Permit Writer's Review Notes  
Worksheets, Etc.

EPU 8-D  
44000023

## STATEMENT OF BASIS

MURPHY OIL  
POPLAR EAST UNIT, ROOSEVELT COUNTY, MONTANA  
UIC PERMIT NUMBER\* MTS21PR-0023

Figure 1. Downhole Schematic and Geology for EPU 8-D.

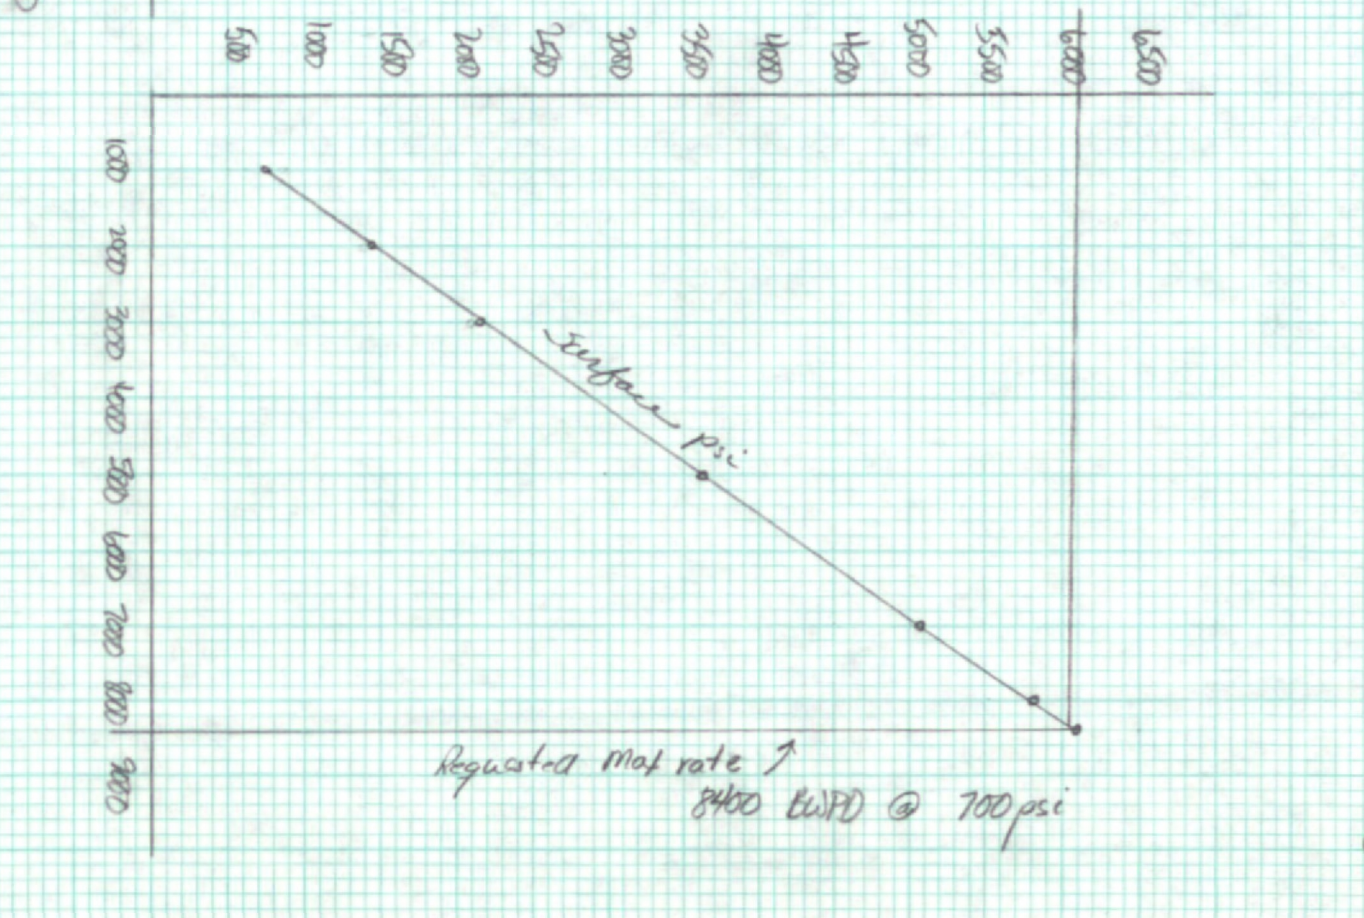
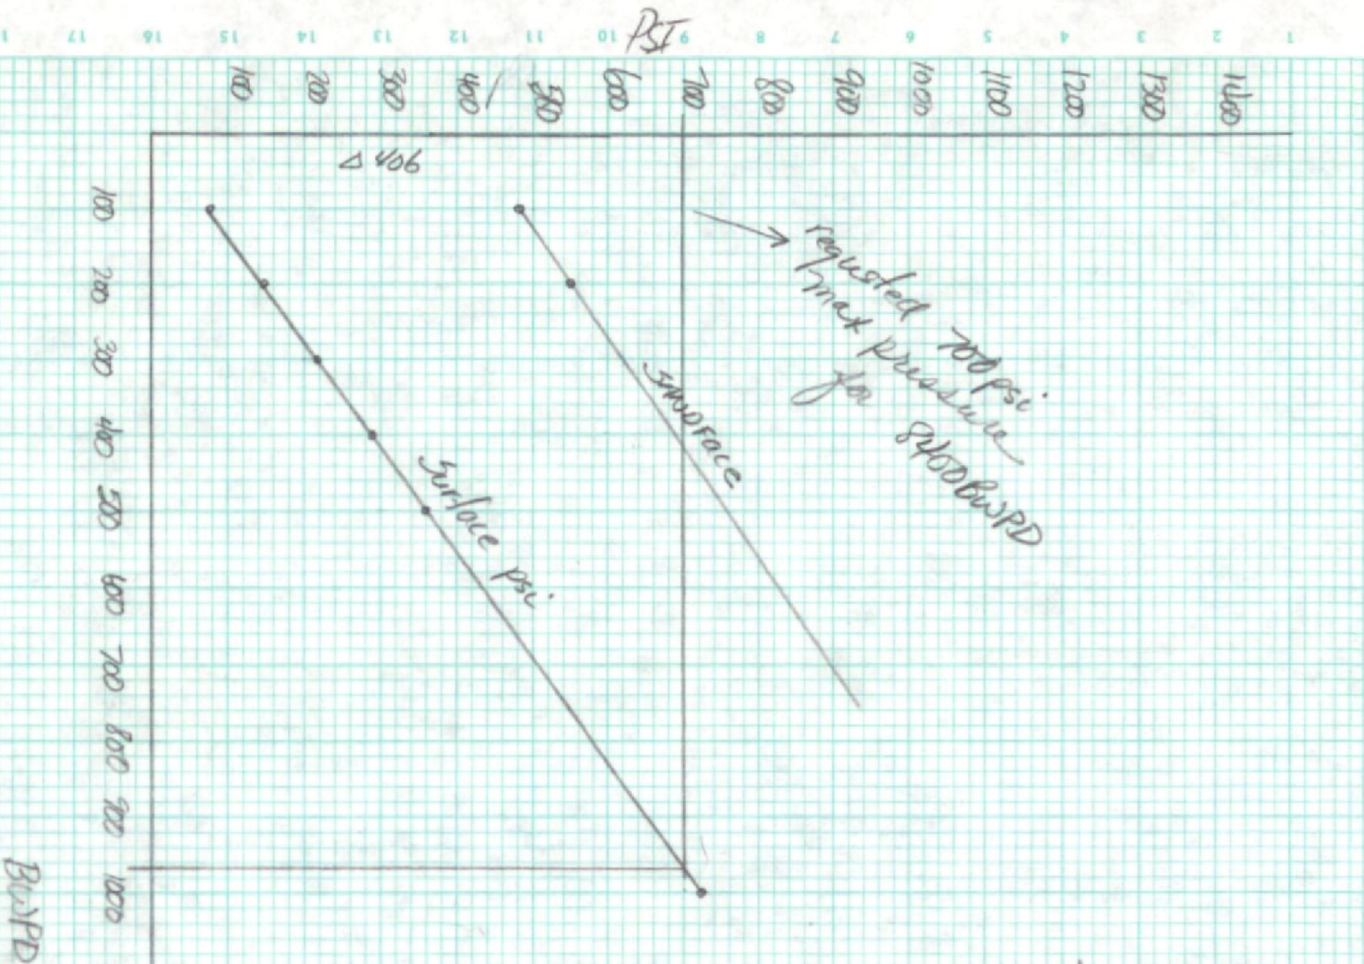
The P&A plan submitted by the applicant with the permit application is incorporated into the permit with changes. The cement in Plug 1 shall be placed across the injection perforations with the bottom of the plug located at 3,583 feet or total depth of well whichever is deeper. The top of the plug is located at 3,070 feet. Plug 2 shall be placed at 700 feet with half the cement inside the 7" casing and half in the 9 5/8 casing/7" casing annulus. The top of the plug remains at 620 feet, as originally designed. Plug 3 shall be placed at 90 feet with half the cement inside the 7" casing and half in the 9 5/8 casing/7" casing annulus. The top of the plug remains at 10 feet, as originally designed. The modified P&A plan shall be binding on the permittee.

The EPU 8-D was constructed in 1955 as an oil producer and converted to a disposal well in 1978. The casing and cementing details were submitted with the permit application and are binding on the permittee. The plugging and abandonment (P&A) plan submitted with the permit application was modified to meet EPA requirements for plugging and abandonment. These changes are binding on the permittee. The downhole schematic and geology are represented in Figure 1. The details of the well construction and P&A plan are delineated in Table 1.

A potential underground source of drinking water (USDW) in this area is a shallow tertiary sand. The Judith River and Eagle formations do not qualify as USDW's because the TDS for either formation is greater than 10,000 mg/l. See the 1985 EPA policy report "Underground Injection Activities into the Judith River Formation on the Fort Peck Reservation" for more information on water quality in the Fort Peck area. Information provided by the permittee indicates the shallow tertiary sand is located in the subsurface interval from 100 to 250 feet and is the lowest most USDW identified by the permittee. In EPU 8-D, the 9 5/8" casing is cemented to surface and effectively seals the tertiary sand from potential migration of fluids (see Figure 1 for specific depths).
